RE: **Coors Pavilion Lot 3 Only**

Hydrology Final Inspection- Approved (Starbucks only)

Re: G11D069A – Lot 3 Coors Pavilion Subdivision Drainage Certification

**LOTS 2 & 3
GRADING & DRAINAGE PLAN**

C-101

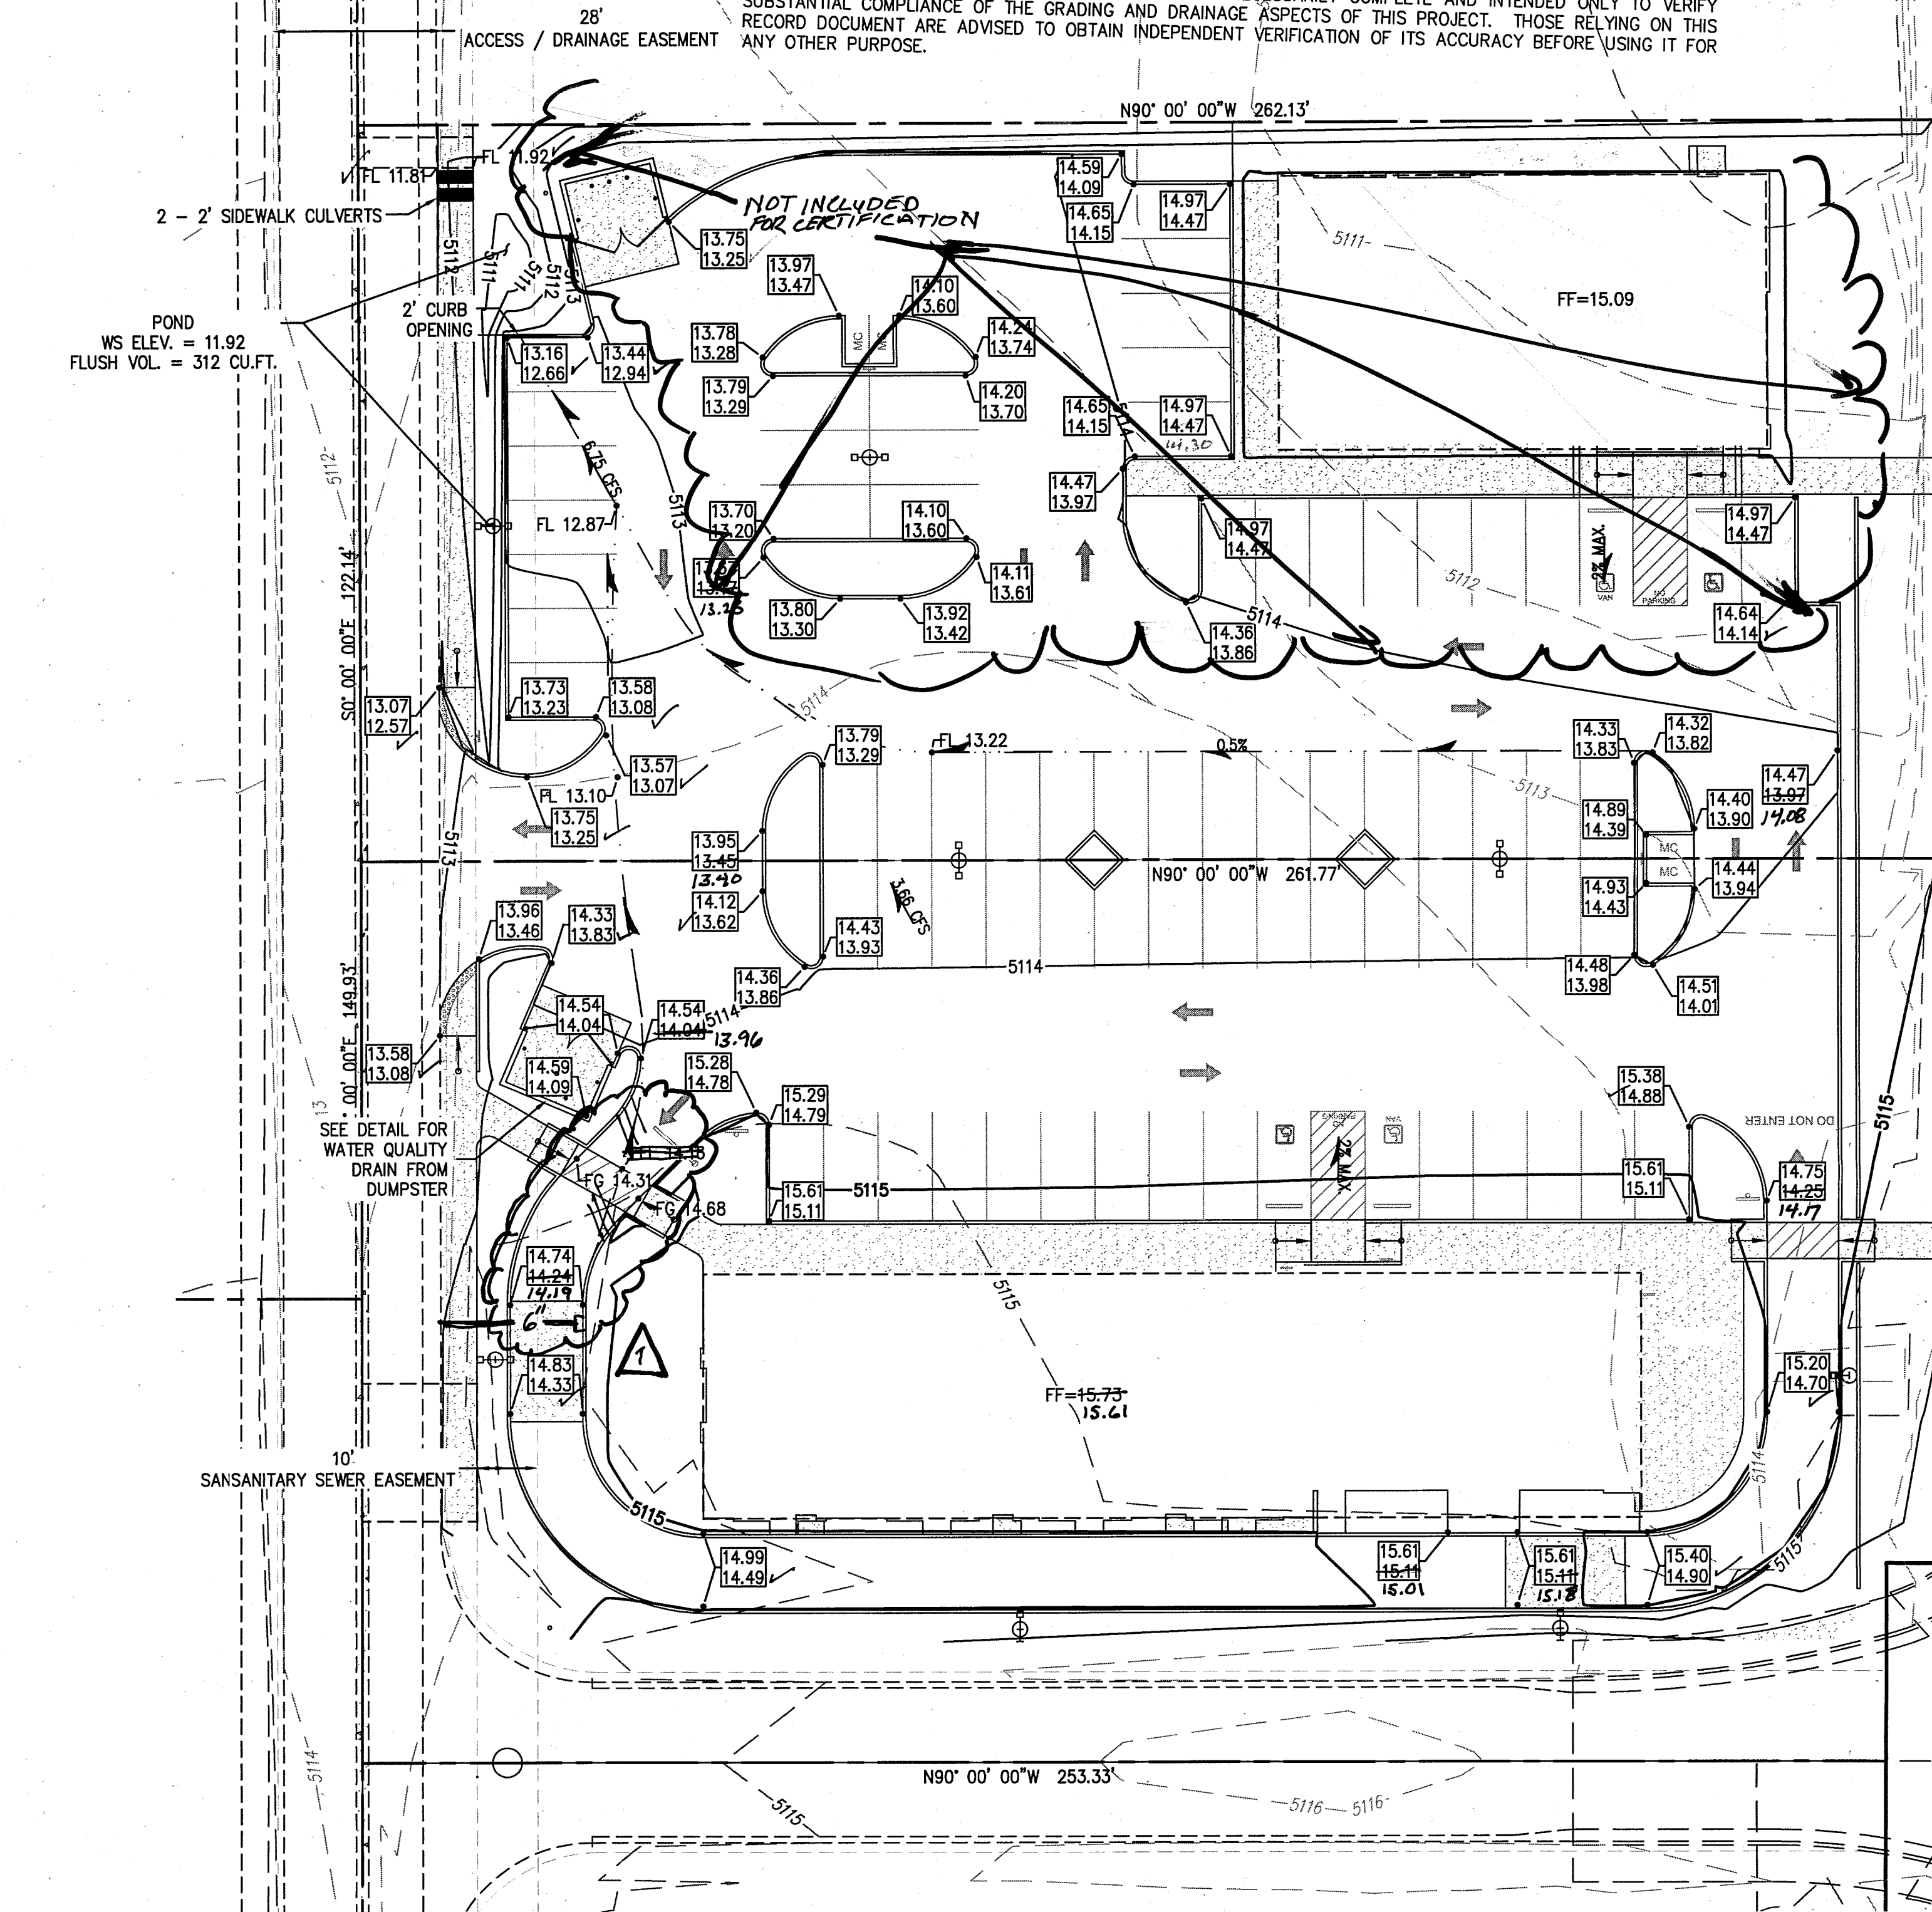
DRAINAGE CERTIFICATION
I, RON E. HENSELEY, NMP# 21850, OF THE FIRM GND, LLC, HEREBY CERTIFY THAT THIS PROJECT HAS BEEN GRADED AND WILL DRAIN IN SUBSTANTIAL COMPLIANCE WITH AND IN ACCORDANCE WITH THE DESIGN INTENT OF THE APPROVED PLAN DATED 5/31/2017, EXCEPTING LOT 2 AND ITEMS DETAILED HEREON AND NOTED BELOW. HUGG, NMP# 9750, OF THE FIRM SURV-TEK, I FURTHER CERTIFY THAT I HAVE PERSONALLY VISITED THE PROJECT SITE ON 11/13/2017, AND HAVE DETERMINED BY VISUAL INSPECTION THAT THE SURVEY DATA PROVIDED IS REPRESENTATIVE OF ACTUAL SITE CONDITIONS AND IS TRUE AND CORRECT TO THE BEST OF MY KNOWLEDGE AND BELIEF. THIS CERTIFICATION IS SUBMITTED IN SUPPORT OF A REQUEST FOR GRADING CERTIFICATION APPROVAL AND CERTIFICATE OF OCCUPANCY.

THE CONSTRUCTED CONDITION WAS NOT BUILT WITH THE INDICATED FLOWLINE. AN AREA DRAIN WAS INSTALLED WITH A 6" OUTLET PIPE DISCHARGING THROUGH THE ADJACENT CURB TO THE DRAINAGE EASEMENT.
